# **HINCKLEY NATIONAL RAIL FREIGHT INTERCHANGE**

## **Stage 1 Road Safety Audits and Response Report (Local Road Network)**

Document reference: 21.1.1

Stage 1 Road Safety Audit

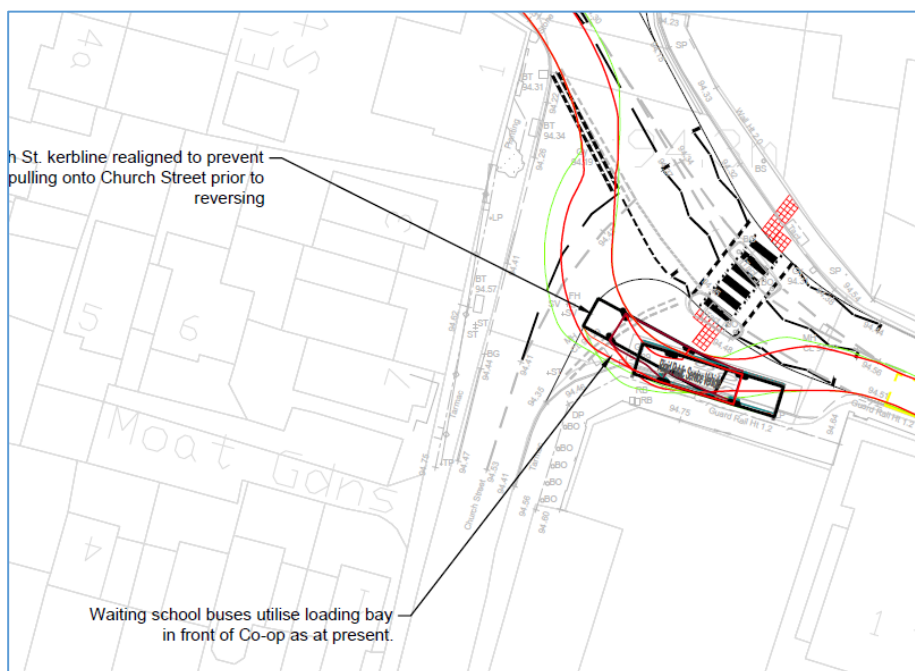
Location: Leicester Road - proposed bus stop / loading bay within “shared space” footway.

Summary: School bus movements within the footway risk vehicle to pedestrian collisions.

Under the existing layout school buses and delivery vehicles are able to pull into the lay-by in front of the Co-op. Whilst the intention is to maintain this existing situation, the changes to the layout here mean that the current lay-by will effectively become (and resemble) footway. This change is likely to result in pedestrians, specifically school children, waiting over a wider area as opposed to being concentrated within the footway when waiting for and alighting from the school bus. There is a concern that this will increase the risk of vehicle to pedestrian collisions, particularly given the complex manoeuvre required to fully enter the bay.

RSA Ref.	RSA Problem and Recommendation	Design organisation response	Overseeing organisation response	Agreed RSA action
	<p>Location: Leicester Road - proposed bus stop / loading bay within "shared space" footway.            Summary: School bus movements within the footway risk vehicle to pedestrian collisions.</p> <p>Under the existing layout school buses and delivery vehicles are able to pull into the lay-by in front of the Co-op. Whilst the intention is to maintain this existing situation, the changes to the layout here mean that the current lay-by will effectively become (and resemble) footway. This change is likely to result in pedestrians, specifically school children, waiting over a wider area as opposed to being concentrated within the footway when waiting for and alighting from the school bus. There is a concern that this will increase the risk of vehicle to pedestrian collisions, particularly given the complex manoeuvre required to fully enter the bay.</p> <p>Recommendation:            It is recommended that an alternative route / provision is created for the school bus stop/loading bay which may require a wider and more considered approach and not one that simply attempts to mirror existing circumstances.</p>	<p>Agree with RSA recommendation: In Part</p> <p>The designer agrees that careful consideration is required regarding the demarcation of any shared surface in this area with suitable tactile and contrasting coloured paving to clearly identify the areas for vehicle use.</p> <p>The Co-op have a service area in their car park on Church Street but the designer were advised by the overseeing organisation that this area is currently used by vehicles servicing the Co-op. It should be noted that it is contrary to traffic regulations for service vehicles to use the existing bus stop, however provision was made in the proposed design, utilising shared surfacing for the delivery vehicle to use this areas in the event that the overseeing organisation elects to amend the relevant traffic regulations.</p> <p>While the majority of passing bus services will use the on carriageway stop (provided on the B4669 as part of the HNRFI works), the overseeing organisation also advised that school bus services currently stop in this area. The swept path movement for buses using the area will be the same as it is currently as the area available is the same. It is the designer's view that the careful use of tactile paving, small kerb upstands and contrasting paving in this location can enable the area to be utilised successfully as a shared surface and to allow buses and school children to wait safely without coming into conflict with each other.</p>

Figure 2 – Problem Location Plan

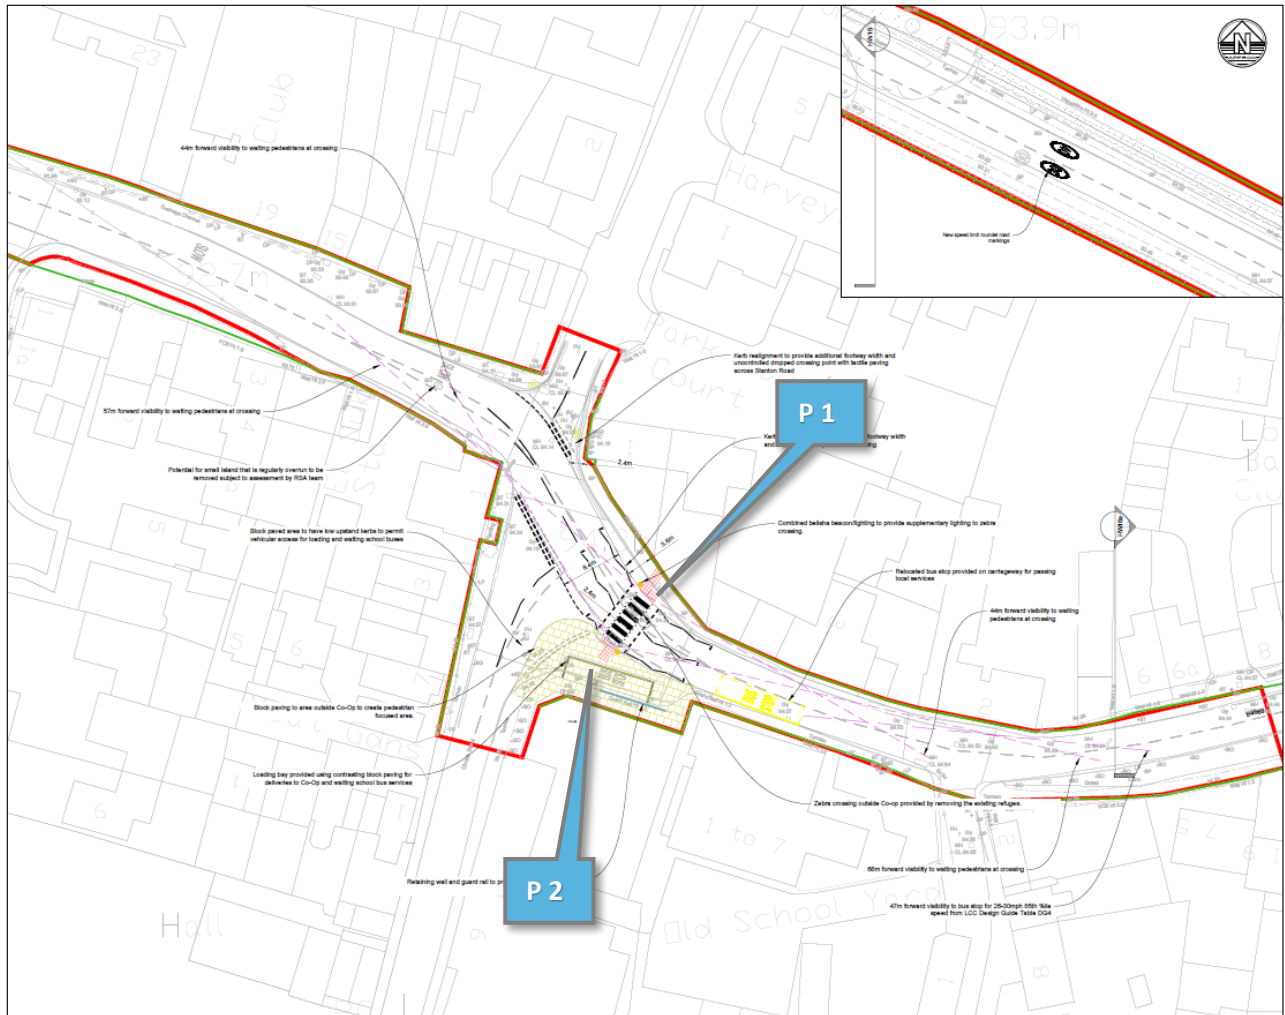
It is recommended that unobstructed pedestrian visibility commensurate with measured vehicle speeds is provided at the crossing point and that this is measured from an appropriate setback from the kerb edge.

RSA Ref.	RSA Problem and Recommendation	Design organisation response	Overseeing organisation response	Agreed RSA action
	<p>Location: Leicester Road - proposed Zebra crossing.</p> <p>Summary: Restricted visibility risks vehicle to pedestrian collisions.</p> <p>Whilst it is appreciated that visibility splays for pedestrians crossing north to south are included in the design, they have been measured from the kerb edge. For most users, especially pushchair and wheelchair users who's viewpoint will be set back from the edge of the footway, visibility for and of these users crossing or waiting to cross is restricted to the east by the building line and boundary wall of the adjacent properties. Should pedestrians enter the carriageway when unsafe to do so there is a risk of vehicle to pedestrian collisions.</p> <p>Recommendation:          It is recommended that unobstructed pedestrian visibility commensurate with measured vehicle speeds is provided at the crossing point and that this is measured from an appropriate setback from the kerb edge.</p>	<p>Agree with RSA recommendation: Yes</p> <p>Measured 85<sup>th</sup> percentile vehicle speeds through this area of Sapcote are 23.5mph westbound and 21.9mph eastbound. At this crossing, the most constrained visibility splay is from the northern kerb line to westbound traffic due to the boundary wall which forms the highway boundary here.</p> <p>There is no specific guidance in LCC's Design Guide, nor Traffic Signs Manual Chapter 6 for measurement of a suitable set-back at a pedestrian crossing. Traffic Signs Manual Chapter 6 Table 15-1 recommends a minimum of 31m stopping sight distance for 85<sup>th</sup> percentile speeds up to 25mph. 31m visibility to westbound traffic from the northern kerb line is achievable at a set-back of 1.2m.</p> <p>LCC's Design Guide does not give specific crossing visibility requirements but Table DG4 provides guidance on visibility distance at junctions, bends and vertical crests. For 85<sup>th</sup> percentile speeds from 21 to 25mph the requirement is 33m for light vehicles and 36m for heavy vehicles. 36m visibility is achievable to westbound traffic from the northern kerb from a set-back of 0.8m.</p> <p>In other directions visibility exceeding those set out here is achievable from a set back of 1.2m.</p> <p>The set-back distances and visibility distances set out above are considered to be suitable for pushchair and wheelchair users and the designer believes that suitable visibility to the crossing is achievable.</p>

Figure 2 – Problem Location Plan

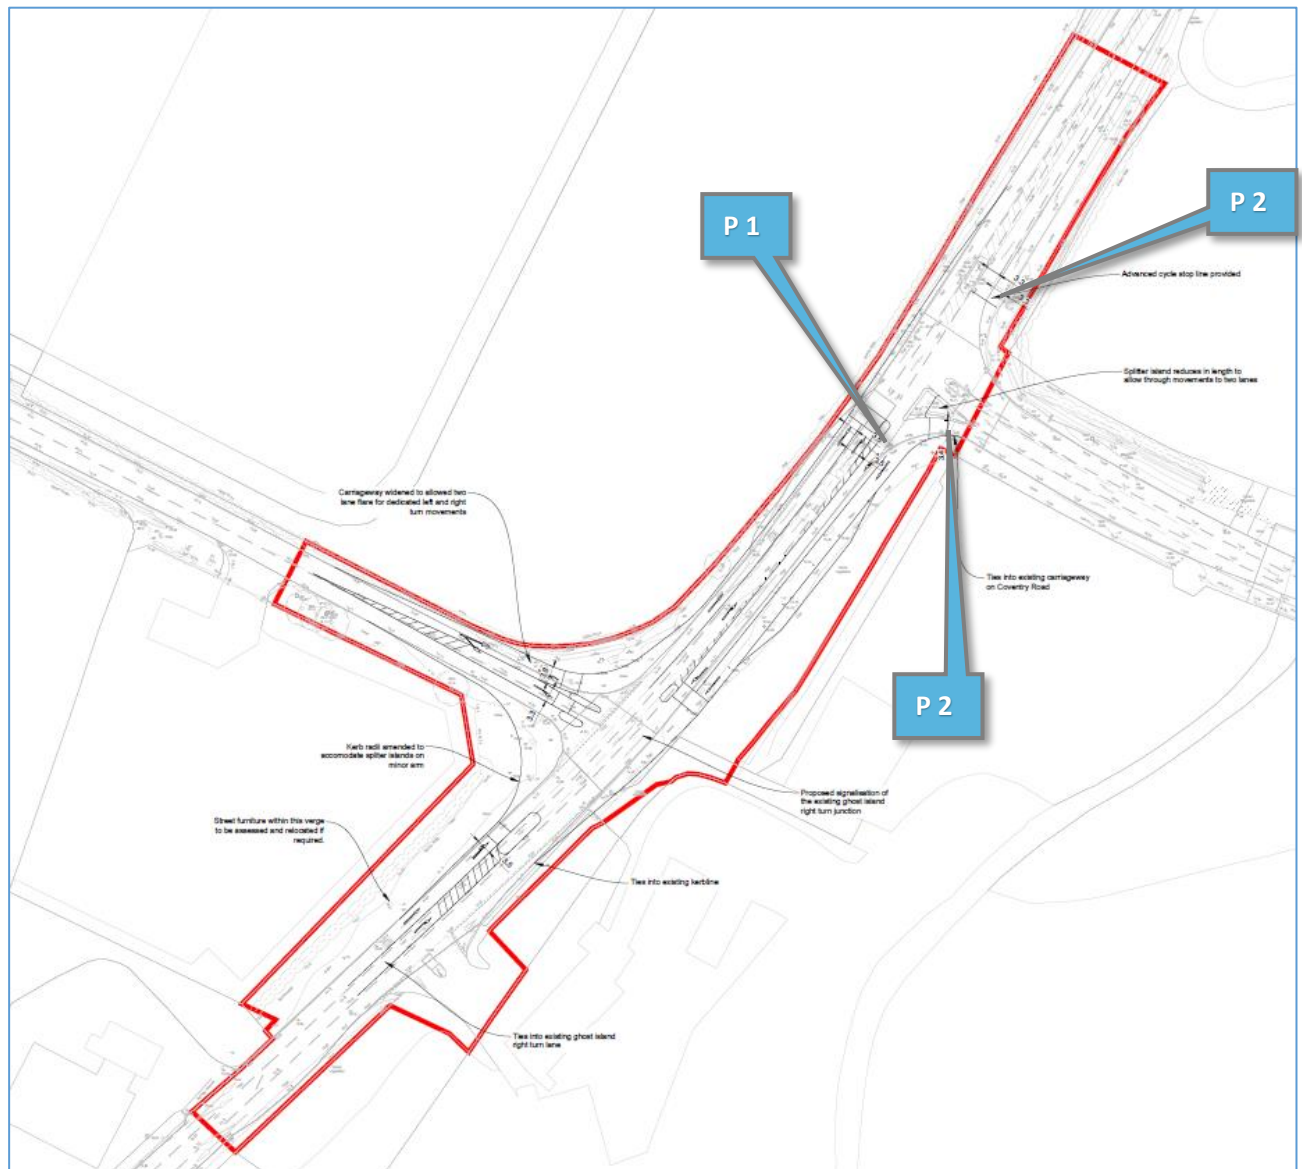
Based on the existing traffic signal layout, the proposed advanced stop line waiting areas on the northern and eastern arms of the junction are in advance of the primary signals within the junction. Should visibility for cyclists towards the traffic signals be restricted there is a risk that following motorists will move off prior to cyclists getting underway, risking collisions between the two.

It is recommended that the signal and stop line arrangements are such that cyclists have a clear view of the traffic signals when waiting within the advanced stop line area.

RSA Ref.	RSA Problem and Recommendation	Design organisation response	Overseeing organisation response	Agreed RSA action
	<p>Location: Existing signalised junction of the B4114 and B581 Coventry Road.</p> <p>Summary: Location of new advanced stop lines limits traffic signal visibility and risks vehicle to cycle shunts / collisions.</p> <p>Based on the existing traffic signal layout, the proposed advanced stop line waiting areas on the northern and eastern arms of the junction are in advance of the primary signals within the junction. Should visibility for cyclists towards the traffic signals be restricted there is a risk that following motorists will move off prior to cyclists getting underway, risking collisions between the two.</p> <p>Recommendation:            It is recommended that the signal and stop line arrangements are such that cyclists have a clear view of the traffic signals when waiting within the advanced stop line area.</p>	<p>Agree with RSA recommendation: Yes</p> <p>Locations of advanced stop lines will be reviewed and amended at detailed design where required.</p>

RSA Ref.	RSA Problem and Recommendation	Design organisation response	Overseeing organisation response	Agreed RSA action
3.3	<p>Location: B4114 Coventry Road – on the exit from the junction with the B581 Coventry Road.</p> <p>Summary: Alignment for straight ahead southbound vehicle movements risks late lane changes and side-swipe type collisions.</p> <p>The alignment of the ahead movement, when travelling southbound, means that drivers are naturally directed to continue into the right turn lane inadvertently, risking late lane changes and potential side-swipe or shunt type collisions.</p> <p>Recommendation:</p> <p>It is recommended that the two-lane arrangement on the exit from the junction is started further south and the road markings amended so as to encourage drivers to make a conscious decision to enter the right turn lane.</p>	<p>Agree with RSA recommendation: Yes</p> <p>The alignment and lane markings will be reviewed at detailed design and amendment made to address the problem.</p>
